**SUPPLEMENTAL INFORMATION FOR THE WALNUT CREEK ENERGY PARK
APPLICATION FOR CERTIFICATION (05-AFC-2)**

In Response to Data Adequacy Review

Walnut Creek Energy Park

(05-AFC-02)

Tue Jan 03 13:46:34 2006

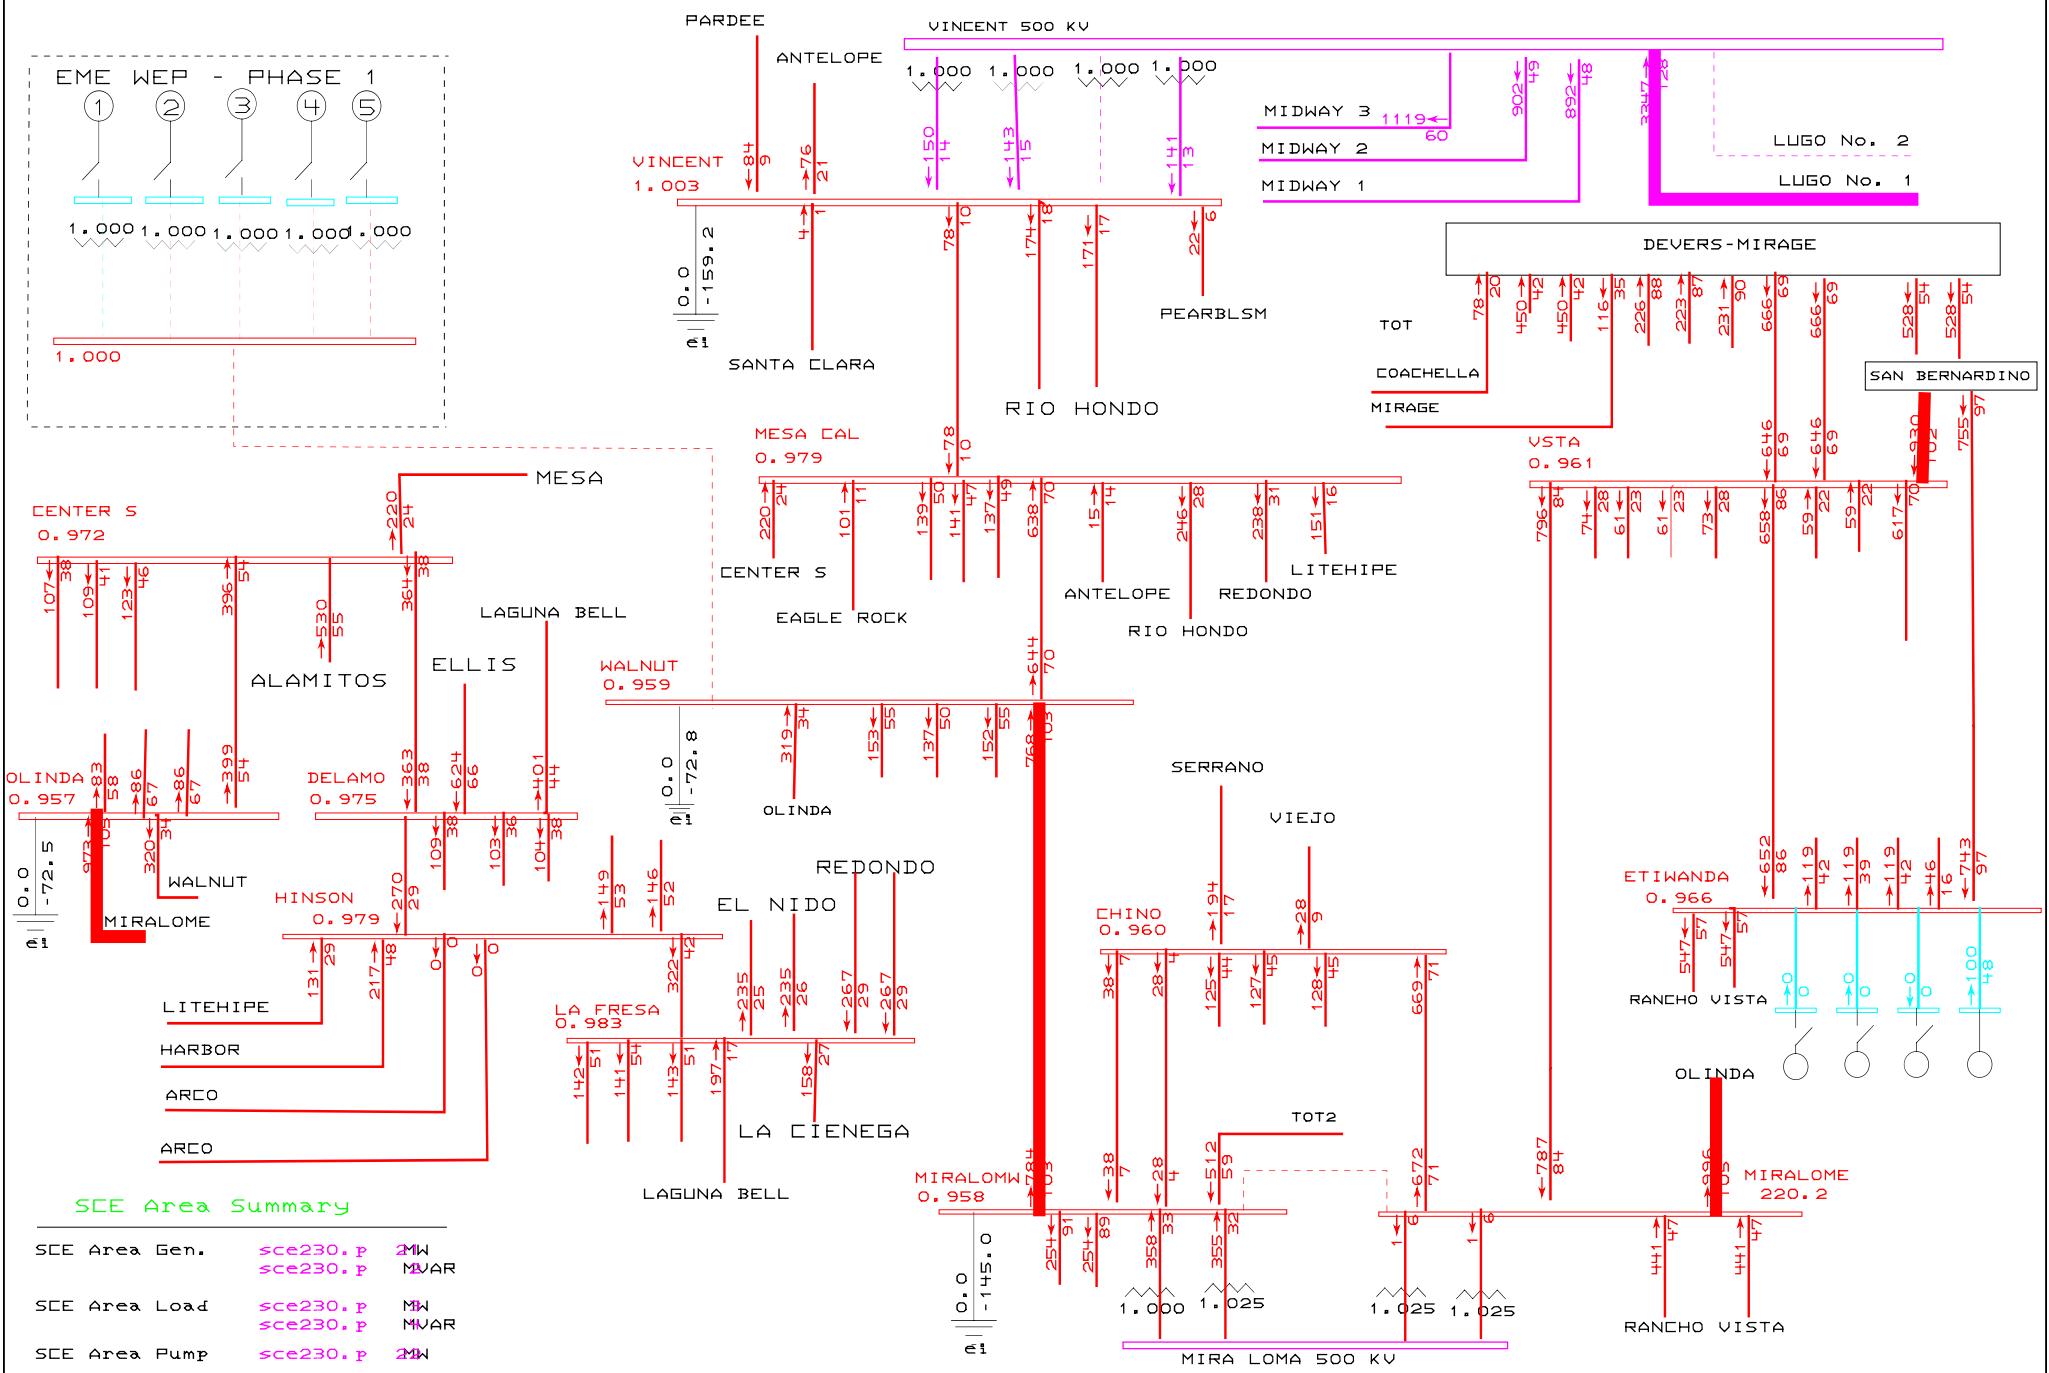
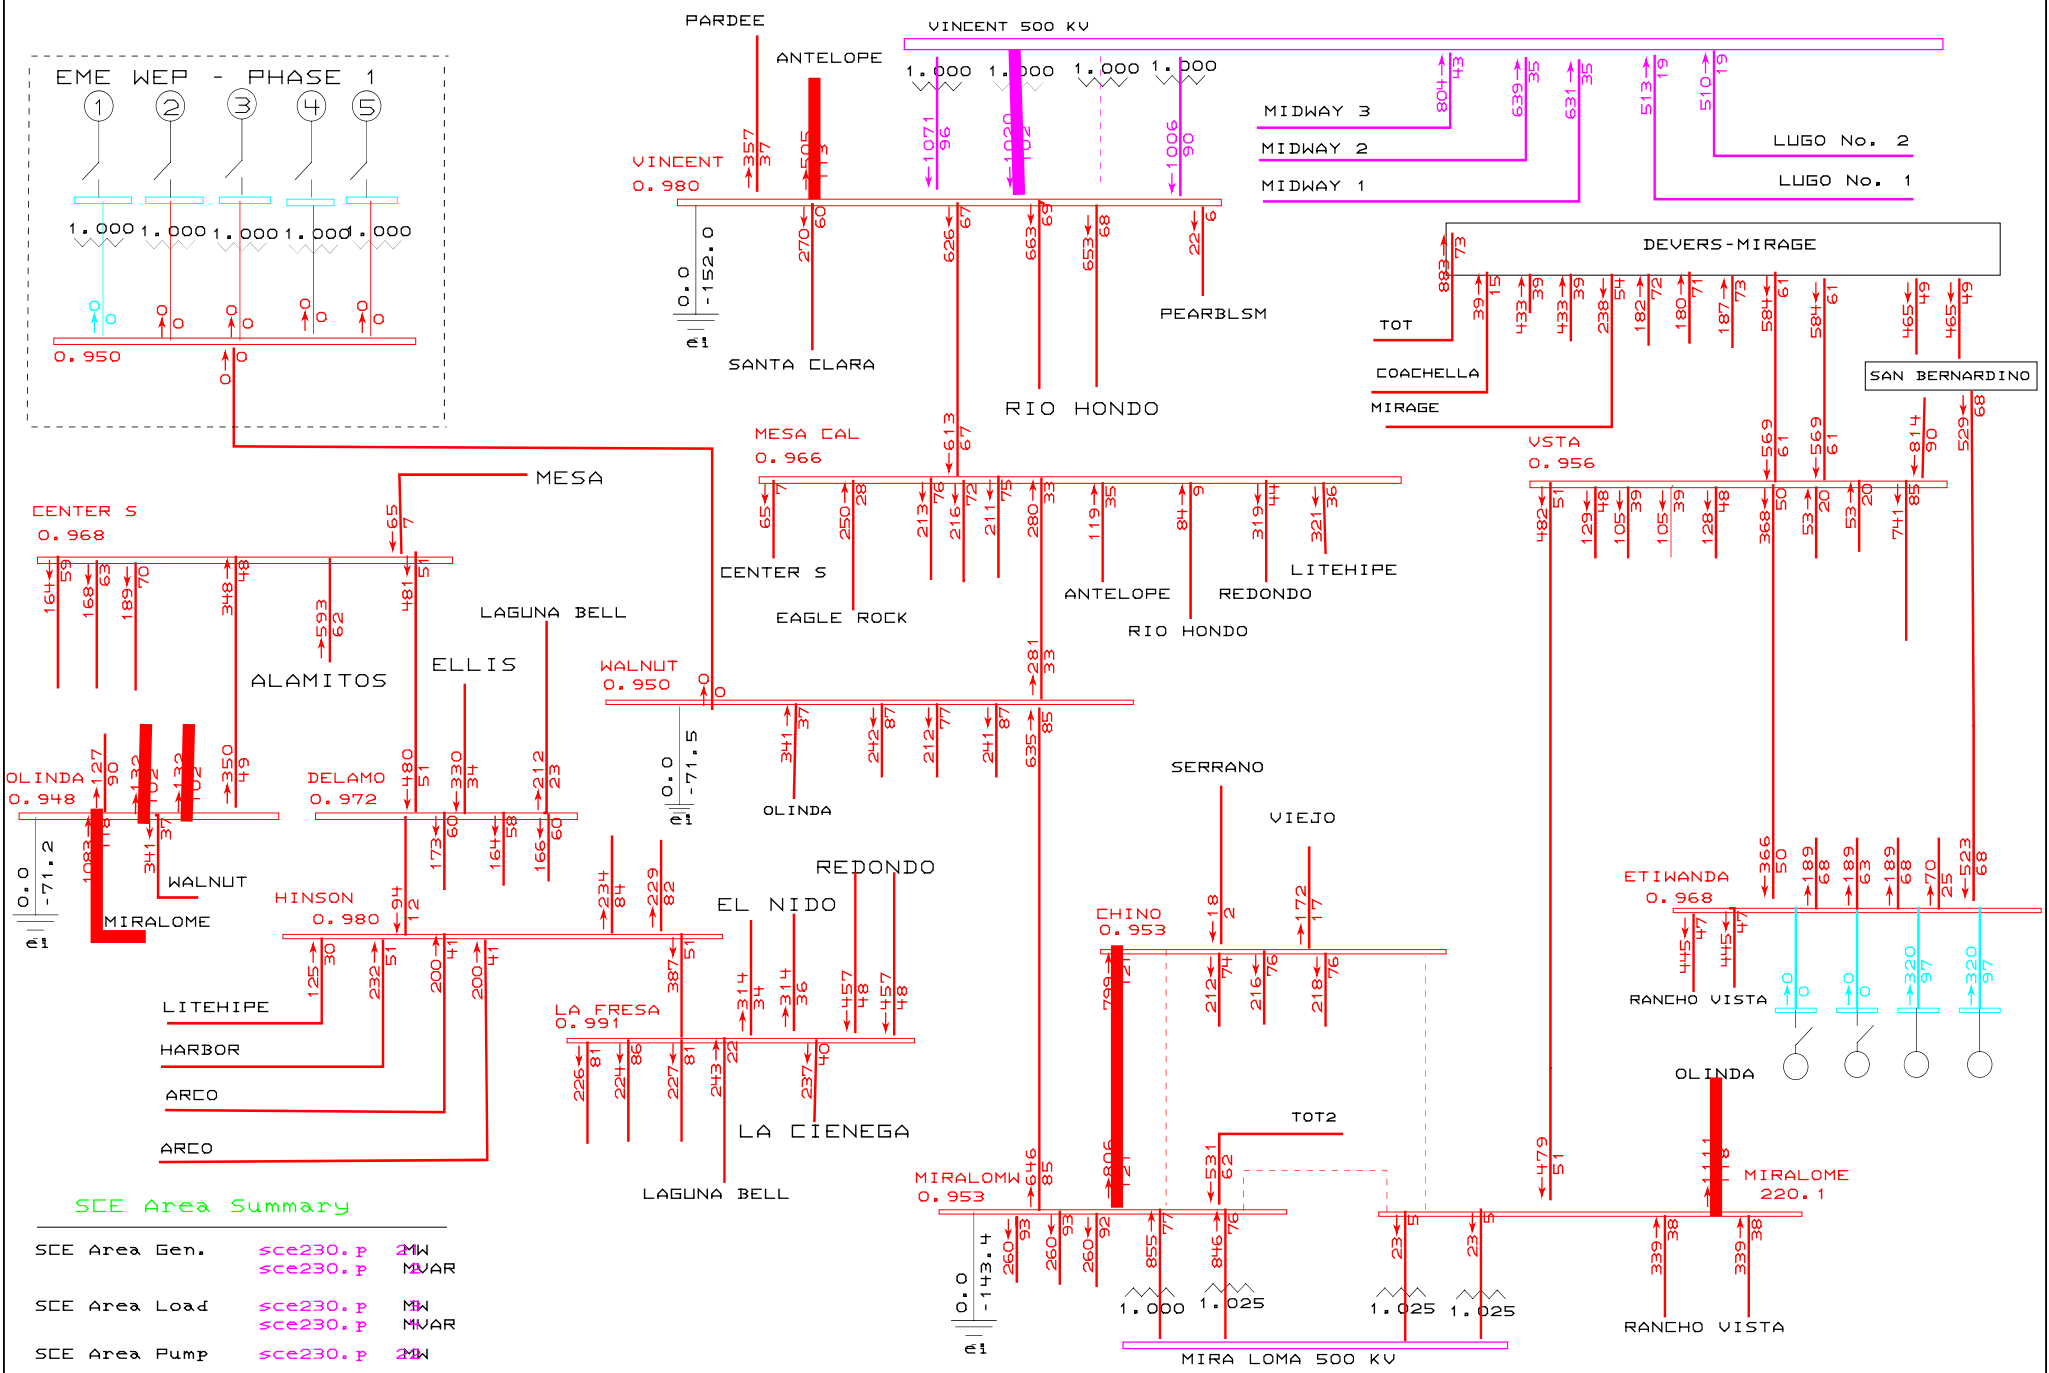
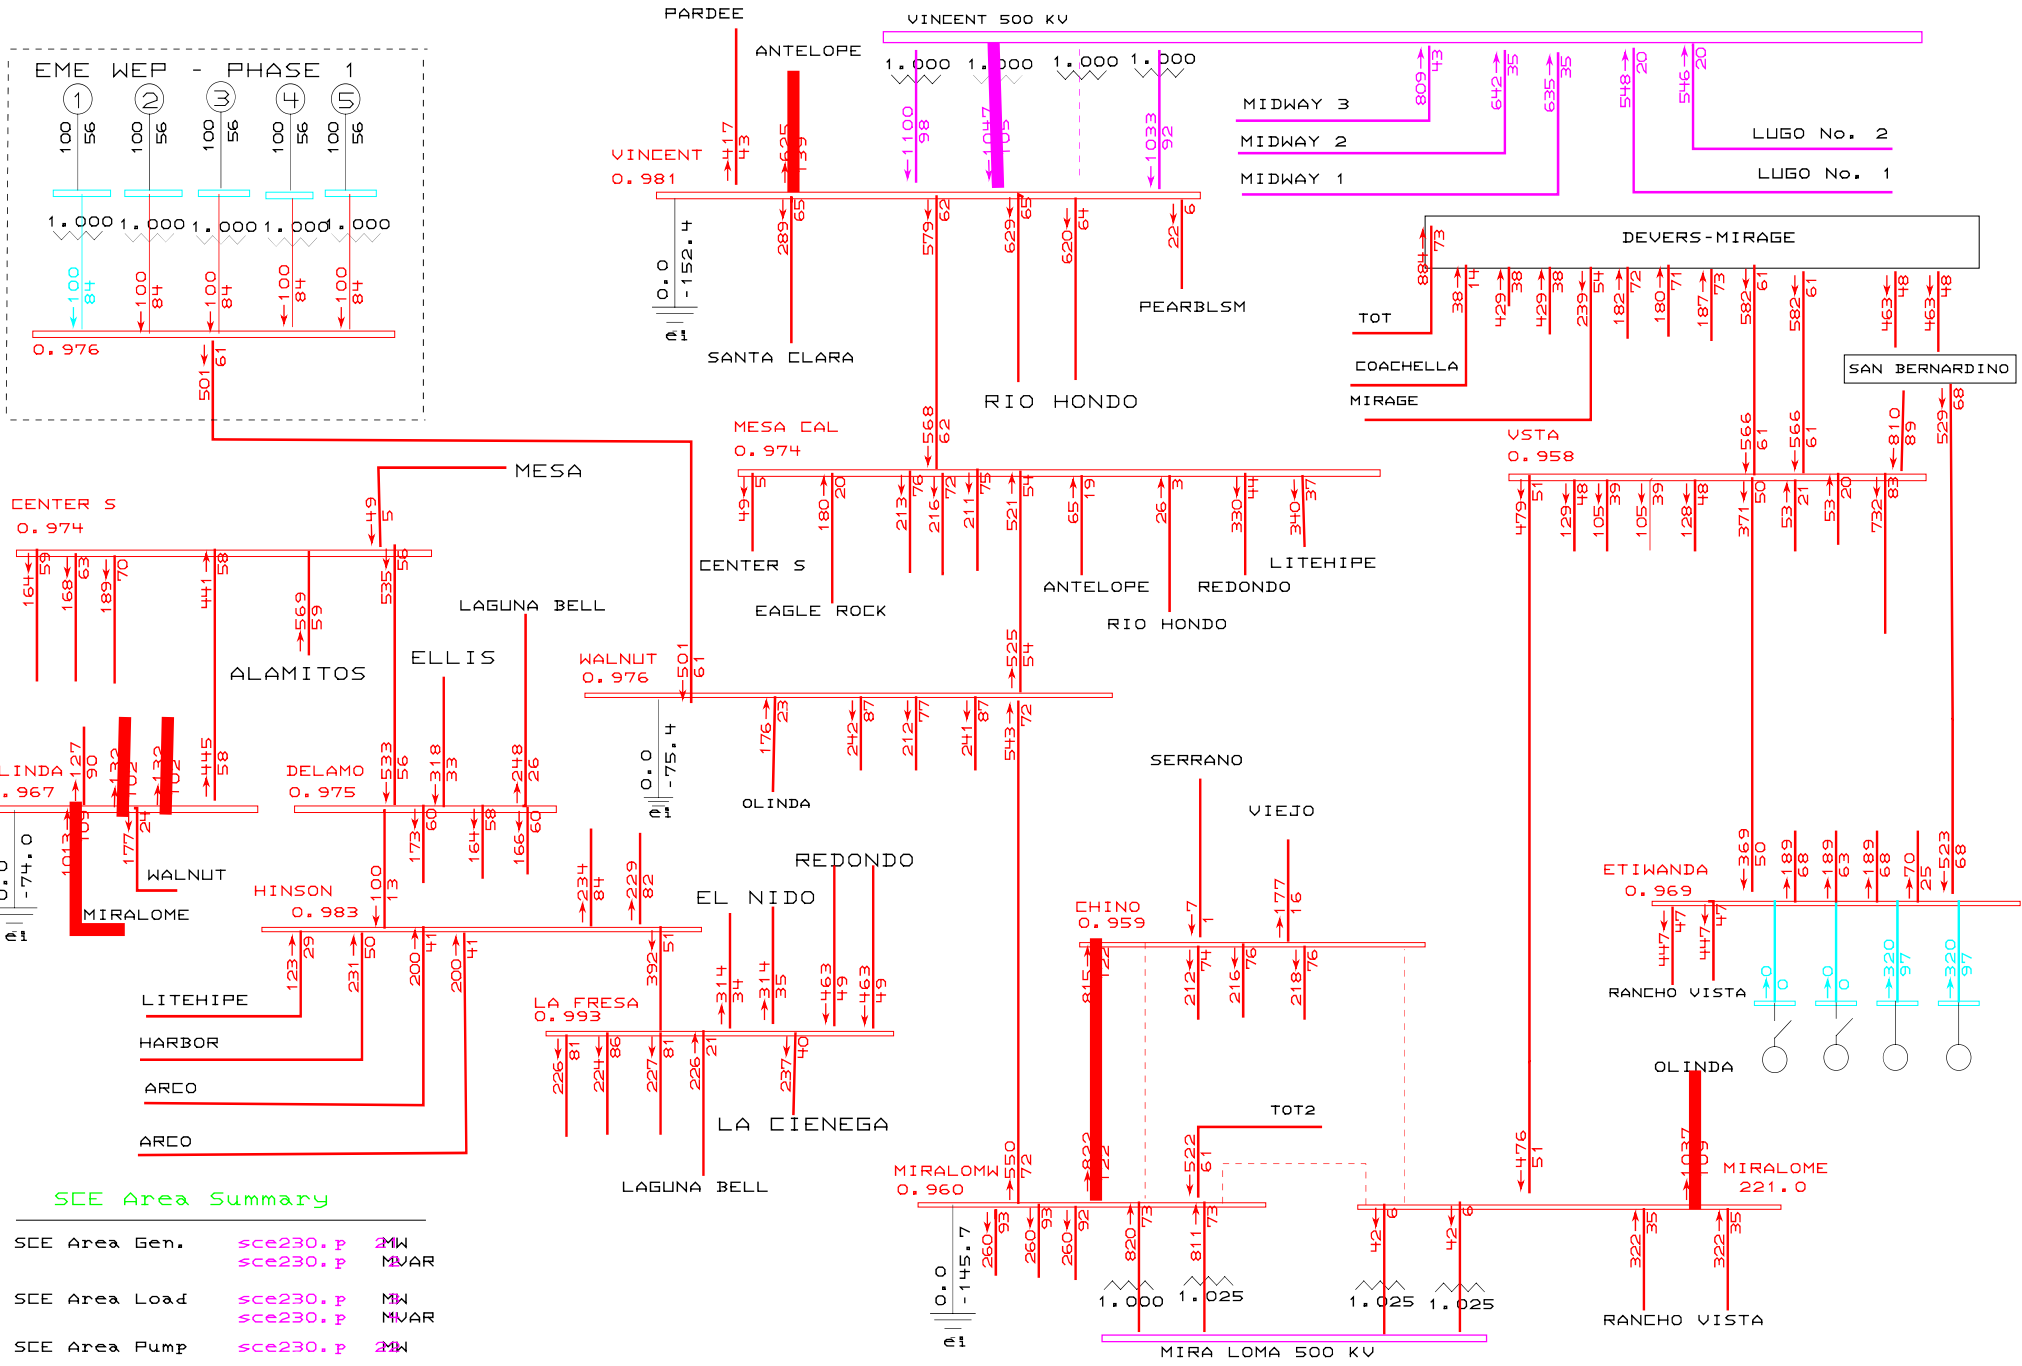
Provide power flow diagrams (MVA, % loading & P. U. voltage) for all N-1 and N-2 contingencies where overloads or voltage violations appear.

Response – Power flow diagrams for cases for which the WCEP would aggravate existing transmission system overloads are attached.
